**FEDERAL AVIATION ADMINISTRATION  
AIRWORTHINESS DIRECTIVES**

**SMALL AIRPLANES, ROTORCRAFT, GLIDERS,  
BALLOONS, & AIRSHIPS**

**BIWEEKLY 2013-09**

*4/22/2013 - 5/5/2013*

Figure 1 to paragraph (f)

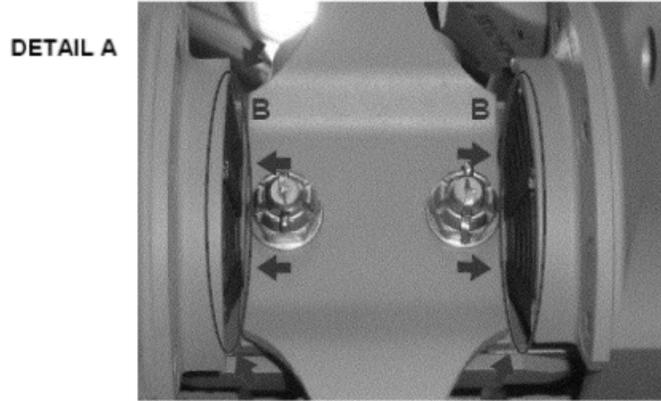
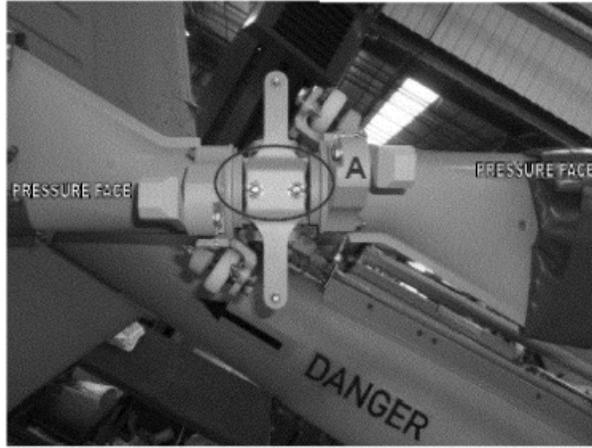
(3) Before further flight, and thereafter after each flight, without exceeding 3 hours time-in-service between two checks, visually check each bearing as follows:

- (i) Position both tail rotor blades horizontally.
- (ii) Apply load (F) by hand, perpendicular to the pressure face of one tail rotor blade (a), as shown in Figure 1 to paragraph (f) of this AD, taking care not to reach the extreme position against the tail rotor hub. The load will deflect the tail rotor blade towards the tail boom.
- (iii) While maintaining the load, check all the visible faces of the bearings (front and side faces) in area B of DETAIL A of Figure 1 to paragraph (f) of this AD for separation between the elastomer and metal parts, a crack in the elastomer, or an extrusion (see example in Figure 2 to paragraph (f) of this AD). A flashlight may be used to enhance the check.

(5) If there is an extrusion on any bearing, before further flight, replace the four bearings with airworthy bearings.

Figure 2 to paragraph (f)

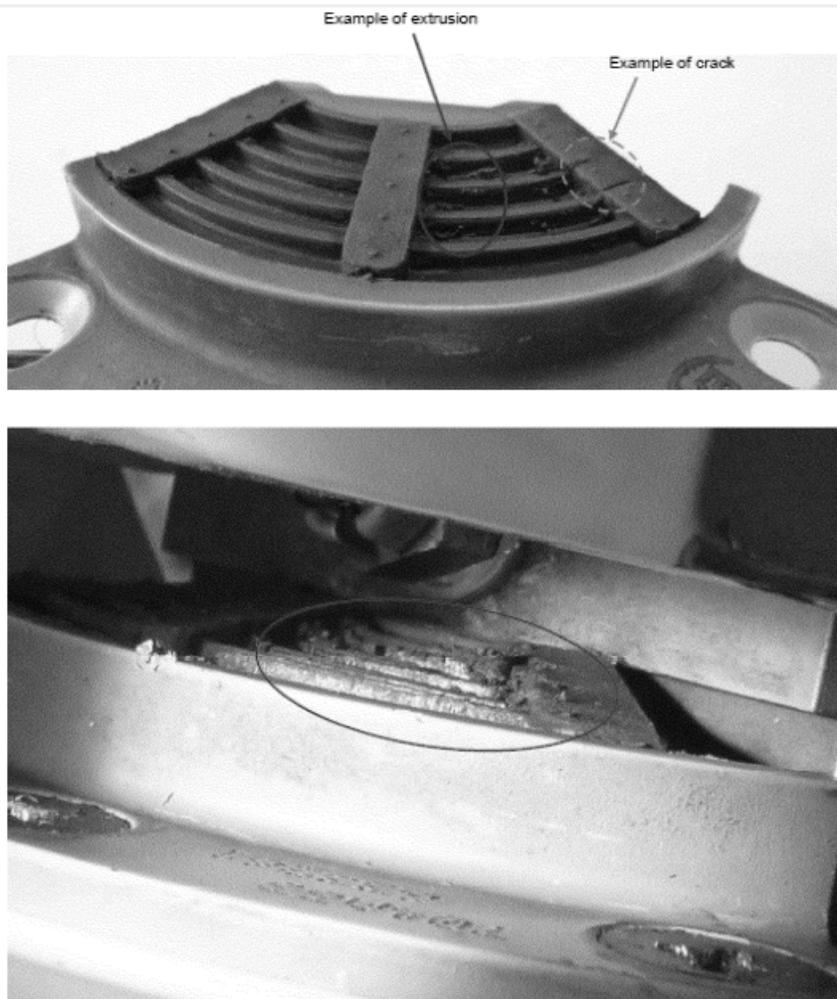
- (iv) Repeat paragraphs (f)(3)(i) through (f)(3)(iii) on the other tail rotor blade.
- (v) Apply load (G) by hand perpendicular to the suction face of one tail rotor blade as shown in Figure 3 to paragraph (f) of this AD. The load will deflect the tail rotor blade away from the tail boom.

Figure 3 to paragraph (f)

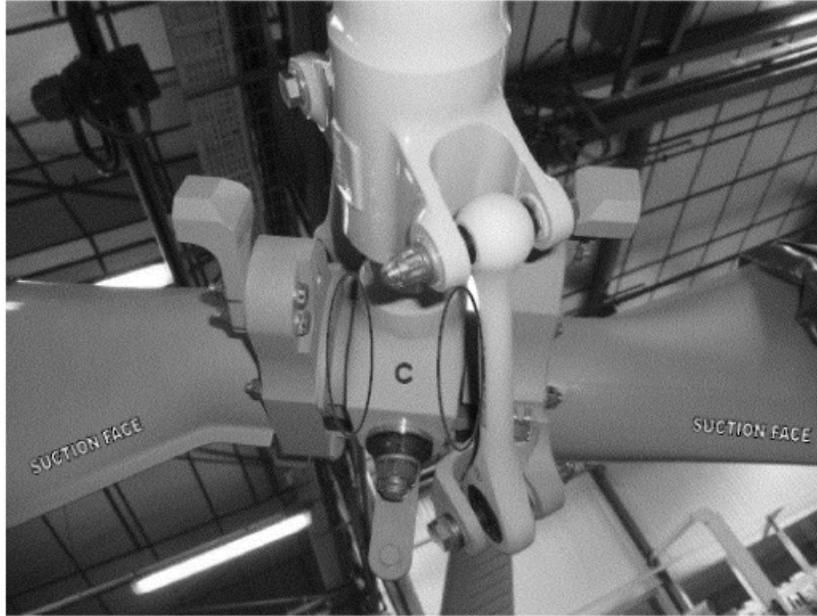
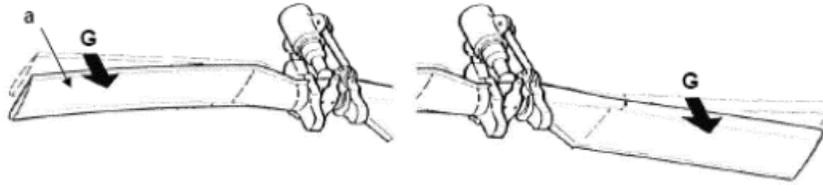
(vi) While maintaining the load, check visible faces of Area C as shown in Figure 3 to paragraph (f) of this AD for any extrusion. A flashlight may be used to enhance the check.

Figure 4 to paragraph (f)

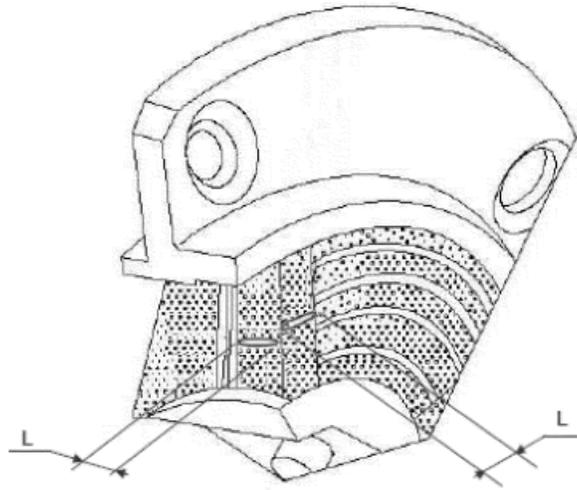
(6) If there is a separation or a crack on the pressure side bearing, measure the separation or the crack. If the separation or crack is greater than 5 millimeters (.196 inches) as indicated by dimension "L" in Figure 4 to paragraph (f), before further flight, replace the four bearings with airworthy bearings.

(7) No later than after the last flight of the day, perform a one-time inspection by removing the bearings and inspecting for a separation, a crack, or an extrusion. This inspection is not a daily inspection. If there is a separation, crack, or extrusion, before further flight, replace the four bearings with airworthy bearings.
